Access Compliance Report

Public Rights-of-Way

Intersection ID: 18172	Main Street: FOREST_GREEN_DR	Cross Street: LITTLE MOSER_LN	Location: NW
ADA ID: 50F847BAE592	Ramp Type: PerpDiag	Initial Pass/Fail: Fail	Overall Compliance: No
Severity Score: 22.5			
Codes/Mitigation Info/Possible Solution		Field Measurements/Component Compliance

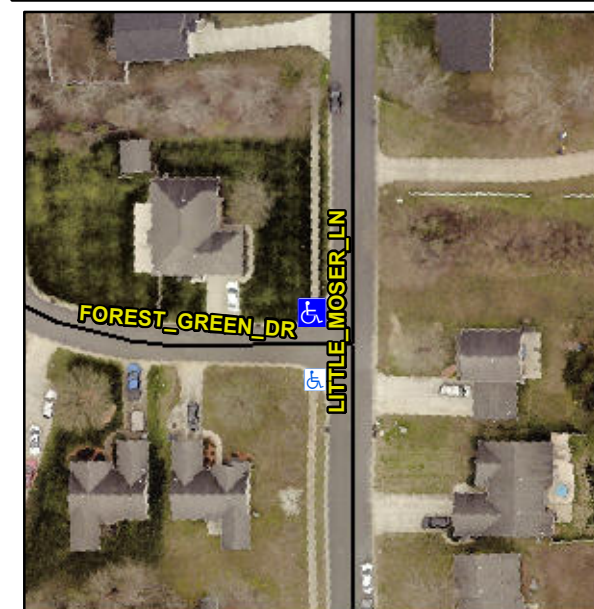
Not Found, R304.5.1, R304.2.2, R304.5.3

Compliance	Description	Data	Compliance	Description	Data
N/A	Ramp Length (in)	45.0	No	Ramp Slope (%)	10.3
No	Ramp Width (in)	36.0	No	Ramp XSlope (%)	4.4
N/A	Flare Type LT	N/A	N/A	Flare Type RT	N/A
N/A	Flare Slope LT (%)	N/A	N/A	Flare Slope RT (%)	N/A
N/A	Flare Traversable LT?	N/A	N/A	Flare Traversable RT?	N/A
N/A	Landing Length (in)	N/A	N/A	DWS Provided?	N/A
N/A	Landing Width (in)	N/A	N/A	DWS Contrast?	N/A
N/A	Landing Slope (%)	N/A	N/A	DWS Length (in)	N/A
N/A	Landing X Slope (%)	N/A	N/A	DWS Full Width?	N/A
N/A	Landing Curb? (Y/N)	N/A	N/A	DWS Offset (in)	N/A
N/A	Shared Landing?	N/A			
N/A	Gutter Ponding?	N/A	N/A	Gutter Slope (%)	N/A
N/A	Gutter Lip Ht (in)	N/A	N/A	Gutter X Slope (%)	N/A
N/A	Painted X Walk1?	No	N/A	Painted X Walk2?	No
	X Walk 1 Direction	To SW		X Walk 2 Direction	To E
N/A	X Walk 1 Width (in)	N/A	N/A	X Walk 2 Width (in)	N/A
	X Walk 1 Slope (%)	1.5		X Walk 2 Slope (%)	3.5
	X Walk 1 X Slope (%)	3.2		X Walk 2 X Slope (%)	1.6

Remove & Replace Curb Ramp With Two New Directional Ramps or Equivalent.
